ARCHITECTURAL REVIEW BOARD STAFF REPORT

Project #/Name	ARB-2013-26: Hickory Hope Apartments (Southwood Block 12)
Review Type	Building Permit
Parcel Identification	09000-00-00-001A1
Location	Northeast corner of the intersection of Old Lynchburg Rd. and Hickory St. (Fig. 1 and 2)
Zoned	Neighborhood Model District (NMD) / Entrance Corridor (EC)
Owner/Applicant	Southwood Charlottesville LLC / BRW Architects (Whitney McDermott)
Magisterial District	Scottsville
Proposal	To construct two 3-story apartment buildings providing a total of 70 residential units as part of a larger development. (Fig. 3)
Context	The site has been cleared. The existing Southwood mobile home community is located to the east of the site. The Ambrose Commons neighborhood is across the Entrance Corridor to the west. Institutional buildings are located to the north on both sides of the street.
Visibility	Both apartment buildings will be readily visible from the EC street. The site plan shows trees to remain in the right-of-way ranging in depth from approximately 40' to 100' along Block 12. When the leaves are off the trees, no real screening is provided. During the summer months the trees may provide some filtering o

Figure 1: A portion of the Southwood site. The architectural design of the buildings shaded gray are subject to ARB review and approval.

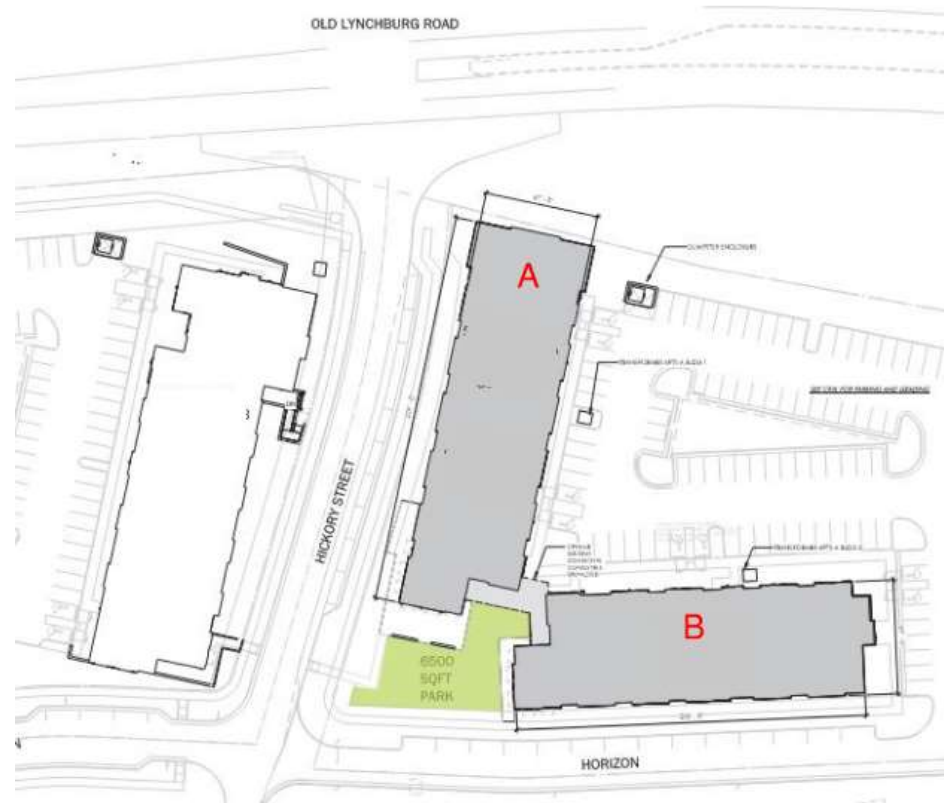
NOTE: This report refers to the building whose long side lies parallel to Hickory Street as Building A and the building whose long side lies parallel to Horizon Street as Building B. (Figure 1)
